# Recall Campaign Bulletin

Campaign No. 2023010003, February 2023

SUBJECT: **Model GLE/ML and GLE Coupe (166 and 292 platform)**  
**Model Year 2016-2020**

## **Check for Water entry in the Spare Wheel Well**

Figure 2

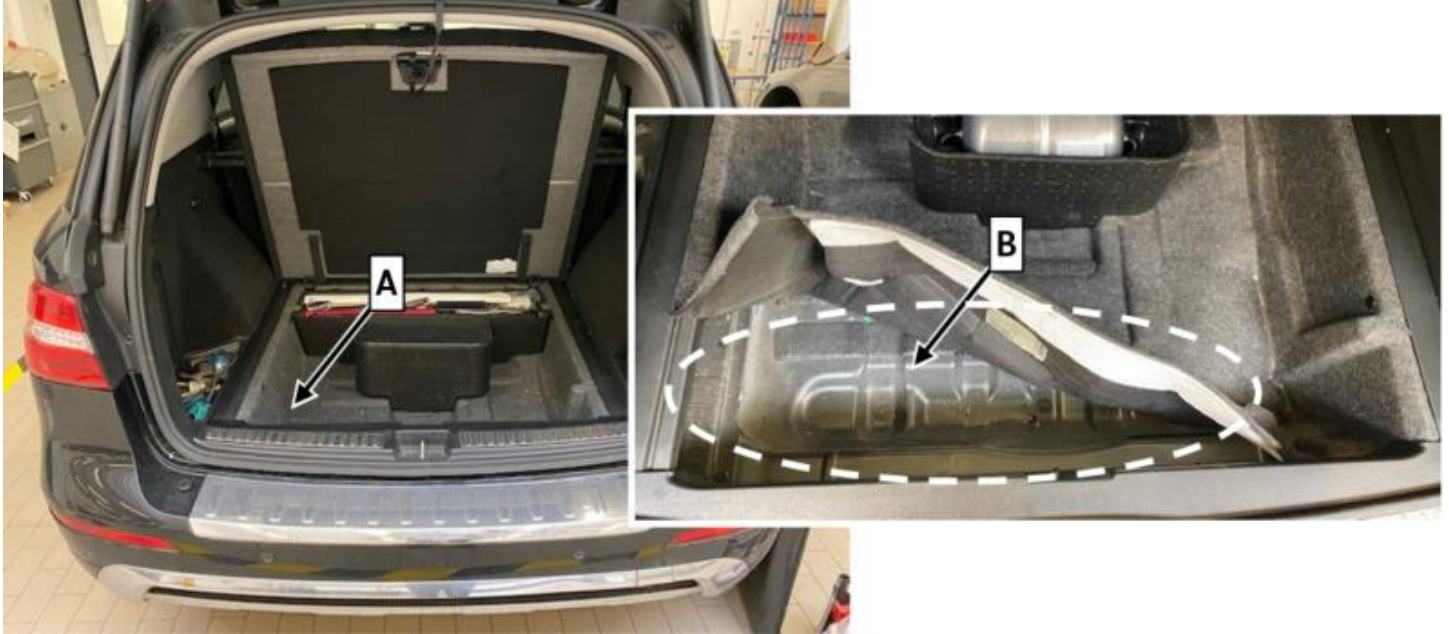
4. Lift left rear felt insert (A, Figure 2) and check for humidity or water deposits in marked area (B, Figure 2).

- a. If humidity or water deposits are **not** present in the area (B, Figure 2): Carry out **work procedure A**.
- b. If humidity or water deposits are present in the area (B, Figure 2): Carry out **check/test procedure B**.

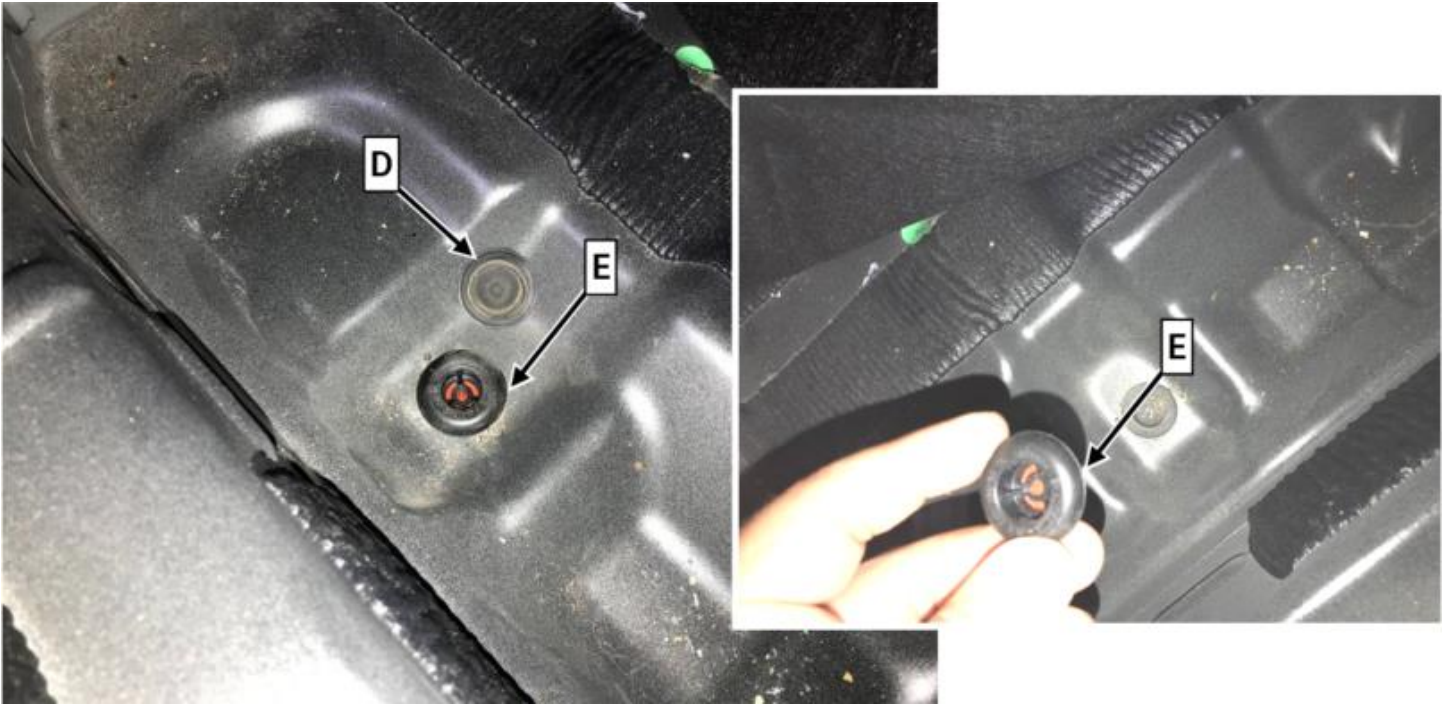
1. Retrofit new water drain grommet (E, Figure 5).  
**i** First remove existing closed grommet (D, Figure 5).
